CERTIFICATE OF APPROPRIATENESS**Application Date:** October 6, 2025**Applicant:** Anthony Monaco, owner

Proposal: New Construction – Single Family Residence with an Attached Garage

SITE PLAN

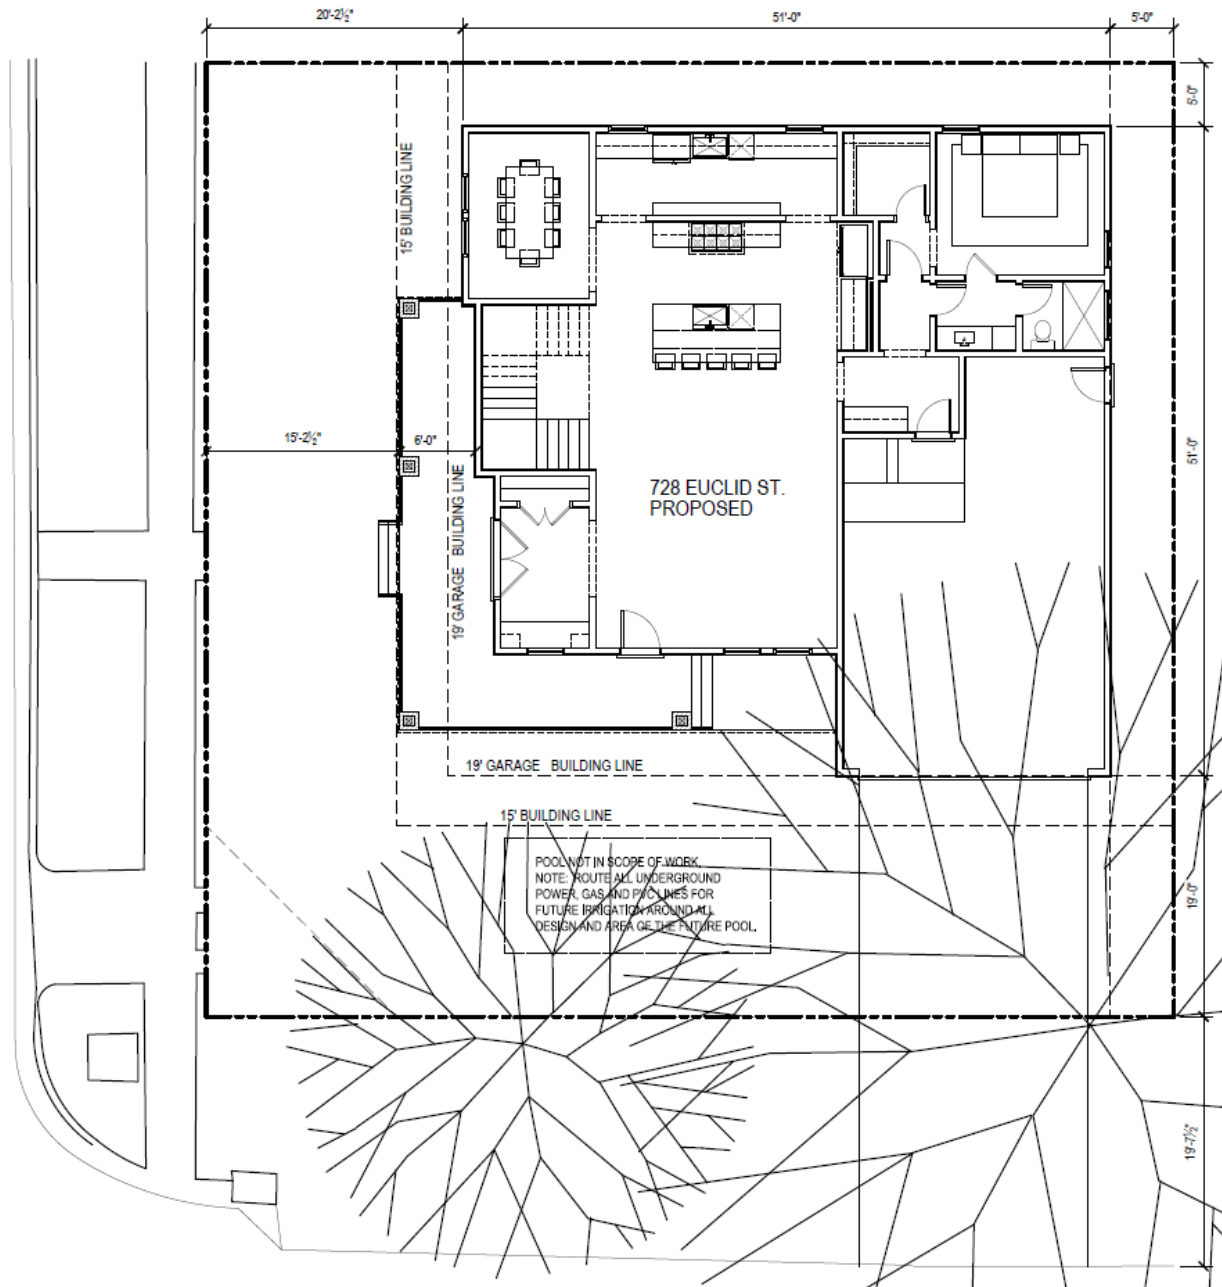
Every house on the south side of Euclid on the 700 block is at least 26 feet set back from the sidewalk. The proposed plans of 17 feet back are inconsistent with the block face, and not appropriate for the historic district. I recognize that a 26 foot offset is difficult to comply with given that the builder would like to put two homes on a lot designed for one, but I am not sympathetic to the builders desire to subdivide the lot at the expense of the historic neighborhood.

Additionally, every home on the 700 block of Euclid has garages in the rear of the home, not built into the house like the builder has designed. The design proposed does not fit into the neighborhood.

Extensive property/building line research of the 700 block of Euclid was conducted by HOP staff to determine the recommended front setback for the proposed new construction should be a minimum of 20'-0" from the front property line. This evaluation was based on the front setbacks of contributing structures in the context area measured on Houston Map Viewer. See pg. 12-13 for more information.
